Final Work Plan for Contamination Delineation at Remedial Unit C5

**Hunters Point Shipyard
San Francisco, California**

**November 2005
Revision 0**

**DEPARTMENT OF THE NAVY
Base Realignment and Closure
Program Management Office West
1455 Franzee Road, Suite 900
San Diego, California 92109**

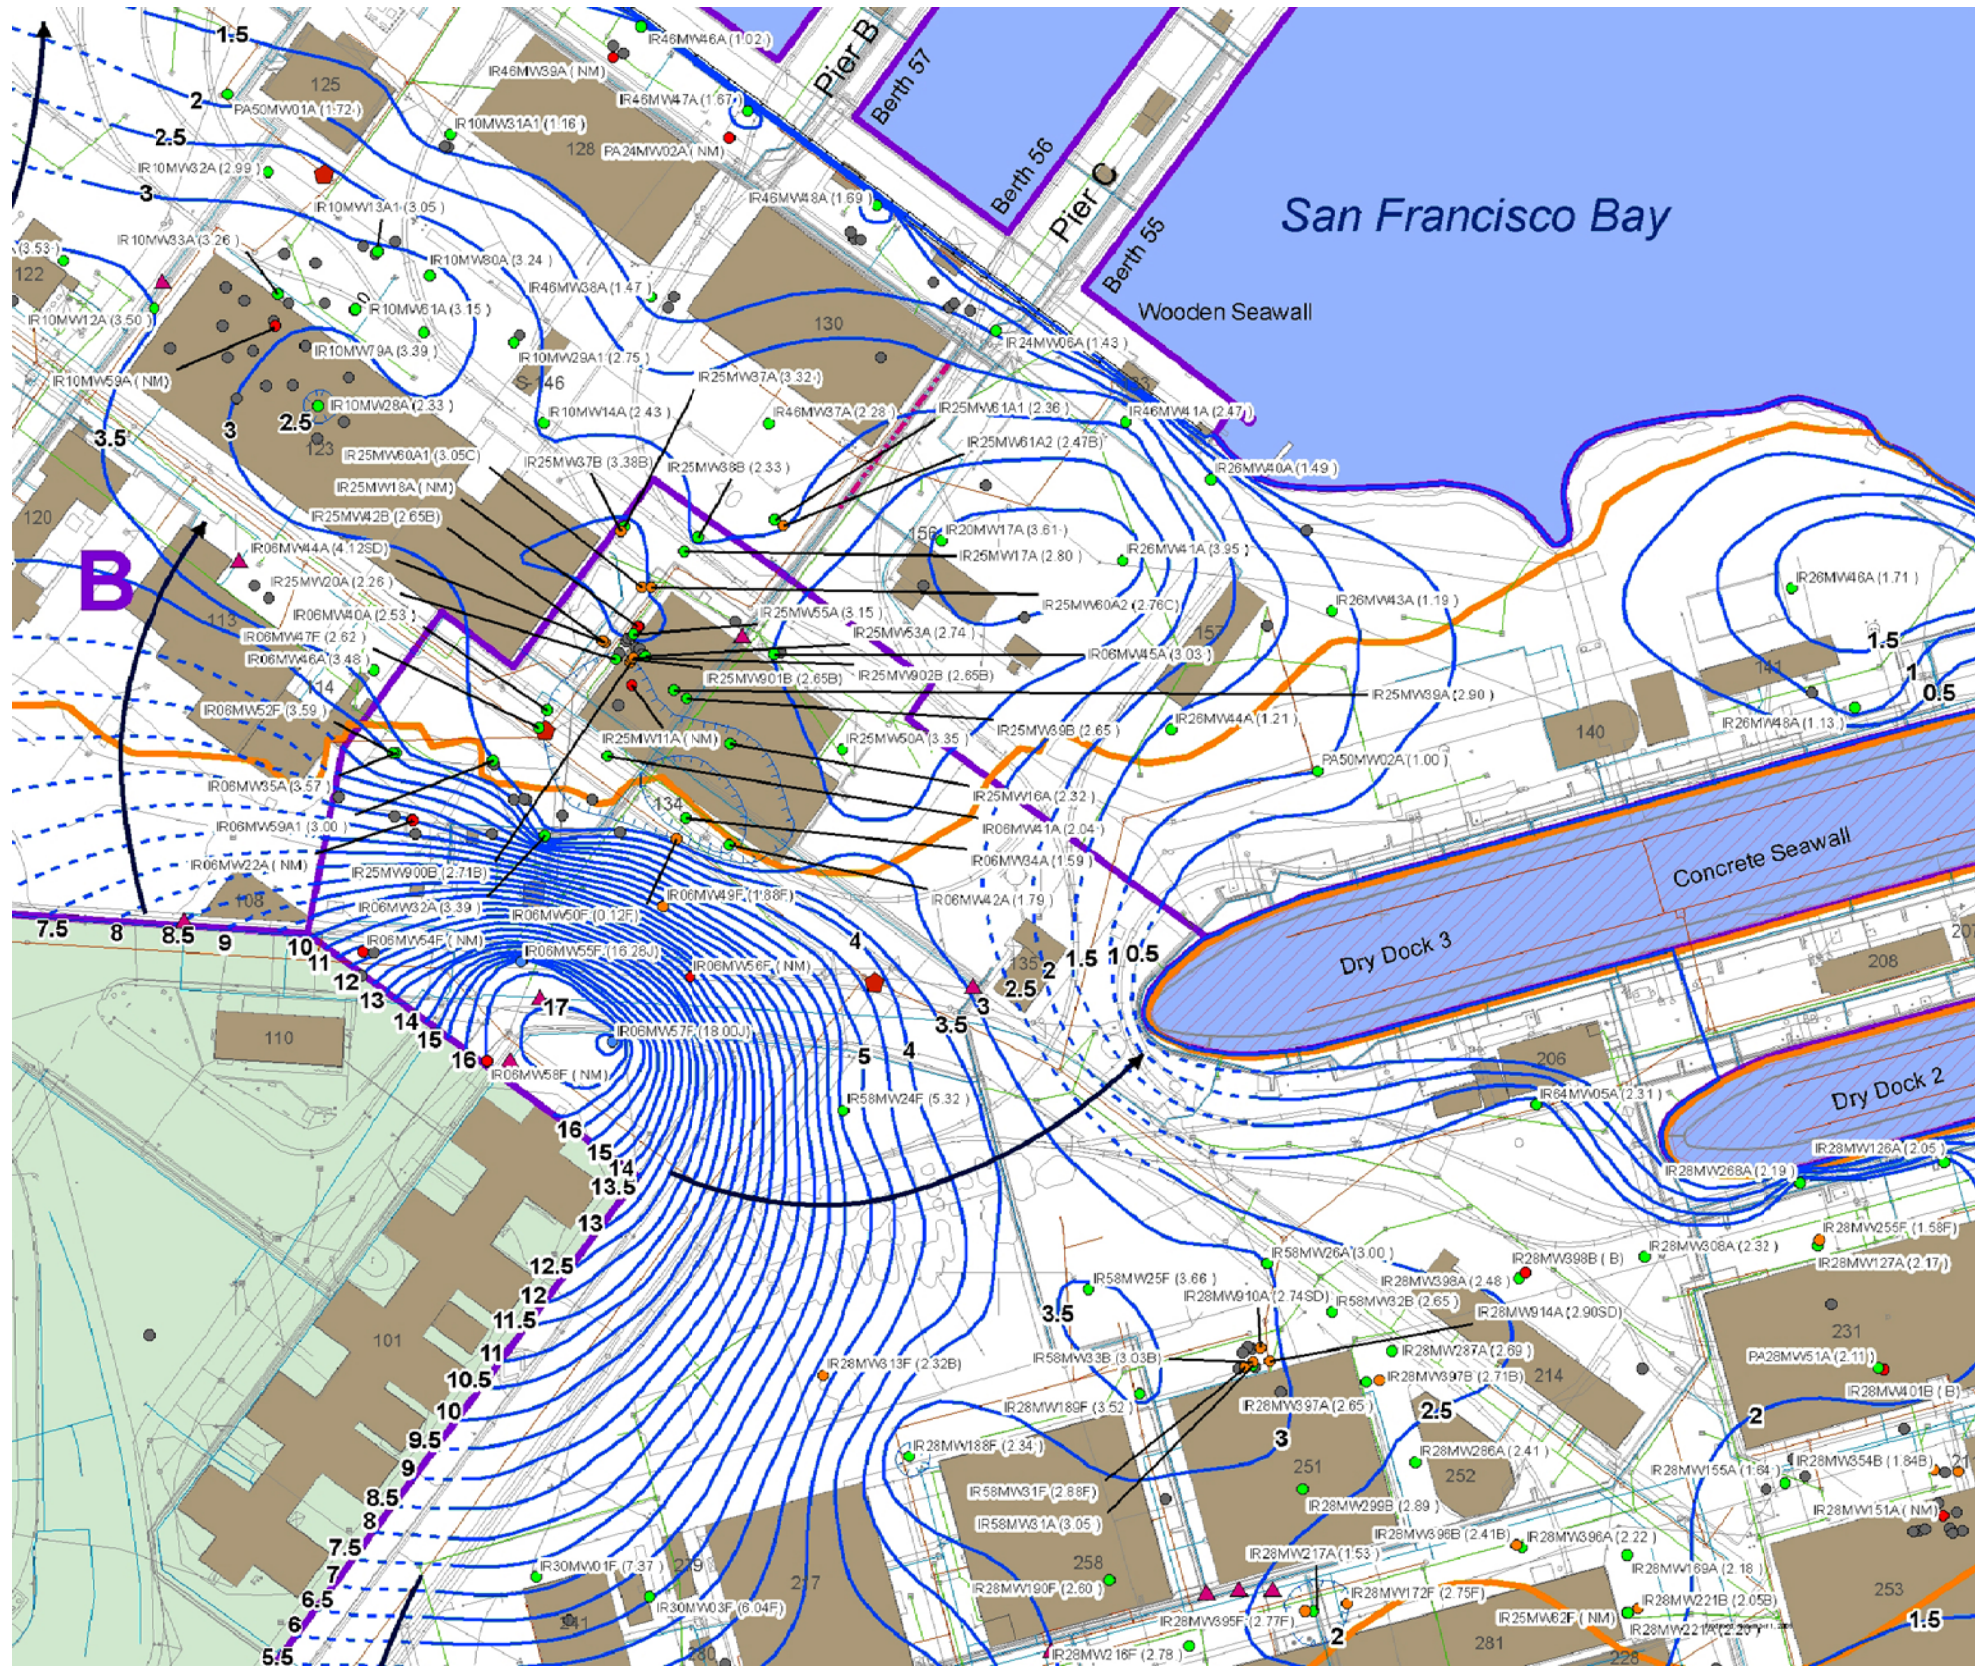
3. In the sections describing the groundwater flow at the facility, the Draft Work Plan (Section 2.3.4) and SAP (Section 1.1.5.4) indicates that the general groundwater flow direction is to the east-southeast, with local components to the northeast and southeast, including a groundwater divide and a groundwater trough, but Figure A-2 does not include sufficient information to support these interpretations. To support these interpretations and the SCM, it is recommended that potentiometric maps for the upper (A1) and lower (A2) aquifers be provided. This would also provide the reader and field team with an understanding of the groundwater flow directions throughout the RU-C5 area. Please provide potentiometric maps for the upper and lower A aquifers.

Response: A potentiometric surface map for the A aquifer (combined upper and lower) has been provided as Figure A-5.

Response: A potentiometric surface map has been added to the SAP as Figure A-5.

A-6

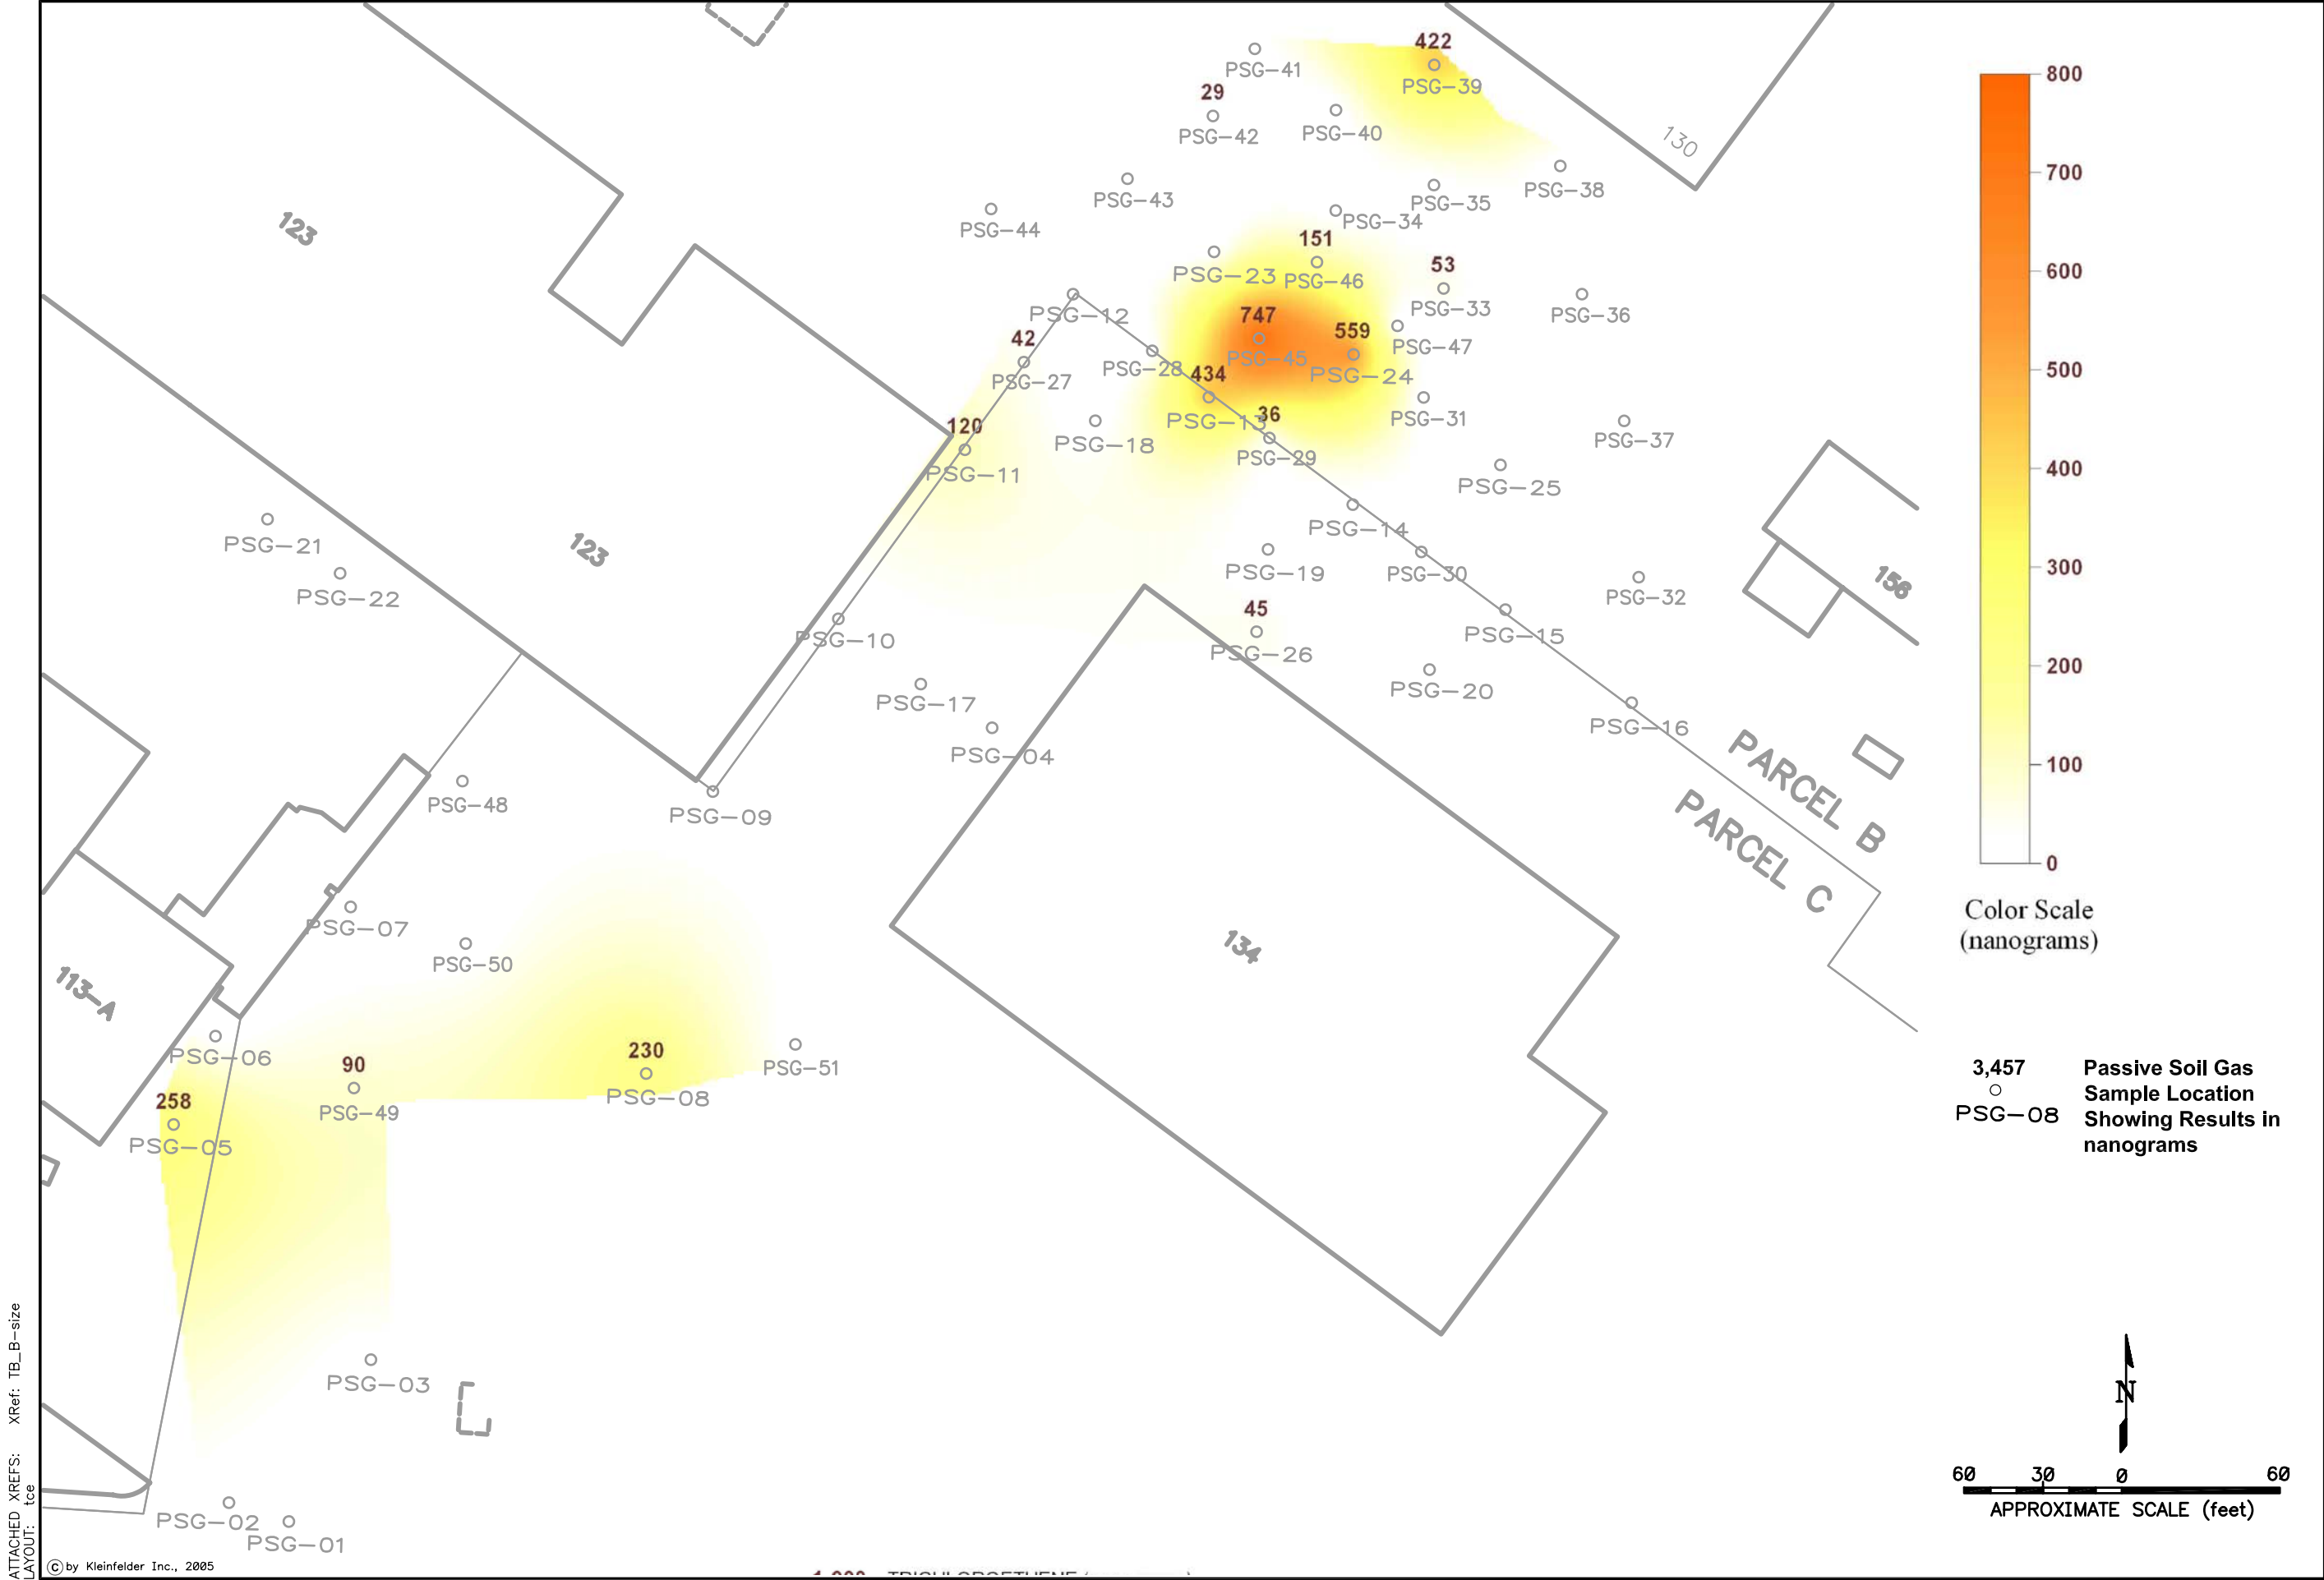
4. In the sections describing the nature and extent of contamination in the RU-C5 area, the Draft Work Plan (Section 2.3.5) and Draft SAP (Section 1.1.5.5) refer to Figure A-2, but the extent of contamination shown on this figure is simply denoted by a stippled pattern over two discreet areas and it is not possible to determine the basis for the interpreted extent of contamination. For example, in the area north of Building 134, the figure indicates that the contaminant plume has crossed the boundary into Parcel B, however, there are no data points to substantiate this interpretation with the exception of monitoring well IR25MW38B (where groundwater contaminants were presumably detected) and monitoring wells IR25MW61A1 and IR25MW61A2 (where groundwater contaminants were presumably not detected). This type of graphical representation does not provide the reader with a definitive sense of the spatial distribution or concentrations of the constituents of concern (COCs) in the soils or aquifers in these areas. To address these concerns, isoconcentration maps of selected COCs in groundwater at IR-25 and IR-06 areas or tables that include historic and recent groundwater VOC data for all of the wells in RU-C5 should be provided. Please revise the Work Plan to include either isoconcentration maps of selected COCs in groundwater or to include tables that include all historic and recent groundwater VOC data for all of the wells in RU-C5.

Response: A map showing the distribution of selected VOCs in groundwater has been provided as Figure A-6.

Response: The Work Plan (Section 2.3.2.2) and SAP (Section 1.1.6) have been modified to include a summary of the anaerobic-aerobic treatability study. A map showing the distribution of selected VOCs in groundwater has been provided as Figure A-6.
